SEWAGE DISPOSAL SYSTEM

MARYLAND STATE DEPARTMENT OF HEALTH

SUBDIVISION Triadelphia Ridge Estates ROAD 13060 Triadelphia Rd LOT 13

SITE PLAN
LOT 13, TRIDELPHIA RIDGE ESTATES
WEST FRIENDSHIP (3RD) DISTRICT
HOWARD COUNTY, MARYLAND
SCALE 1" = 100' JULY, 1988

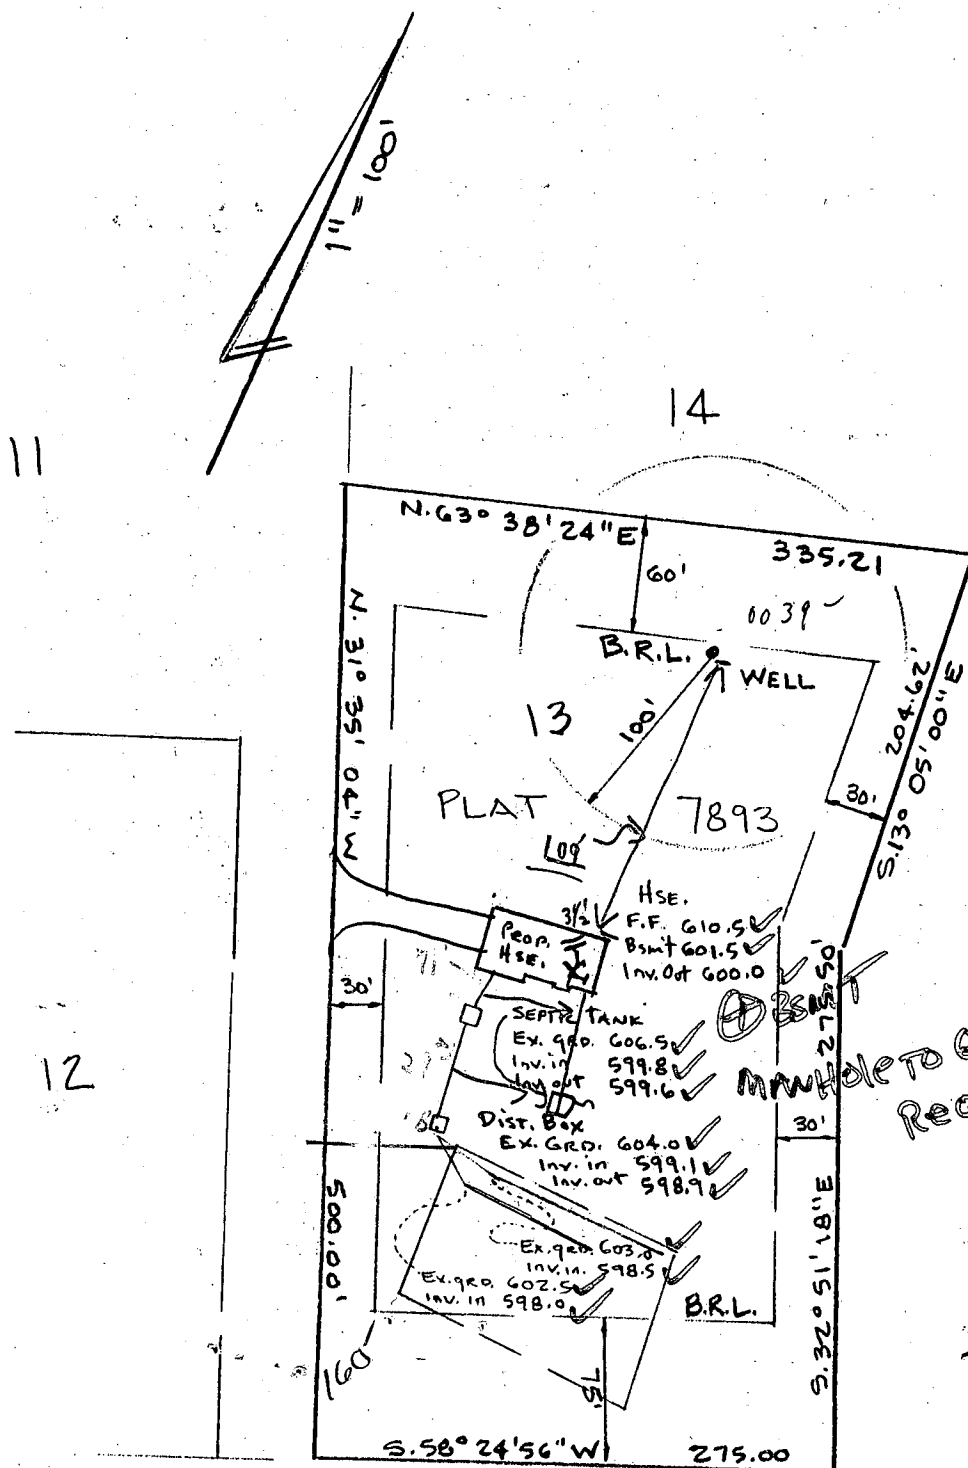
Note
R.M.
4/25
W.P.I
No line
No etc
Nath
C.B.R.

MANHOLE TO GRADE
REQUIRED
SA

elevation on
SAB

known as: LOT 13

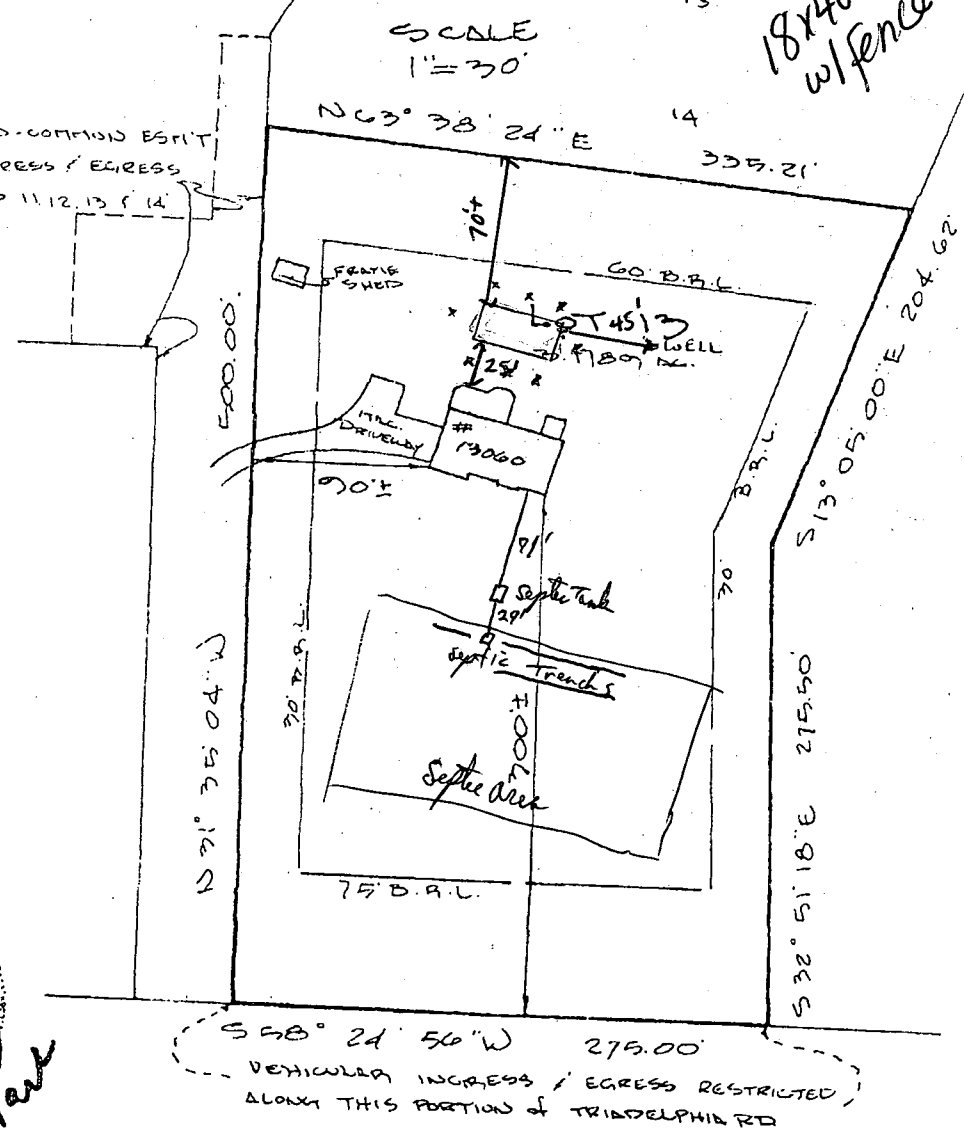
In Ground Pool
No conflict with well
or Septic. basement
approval: R/P 5/4/00
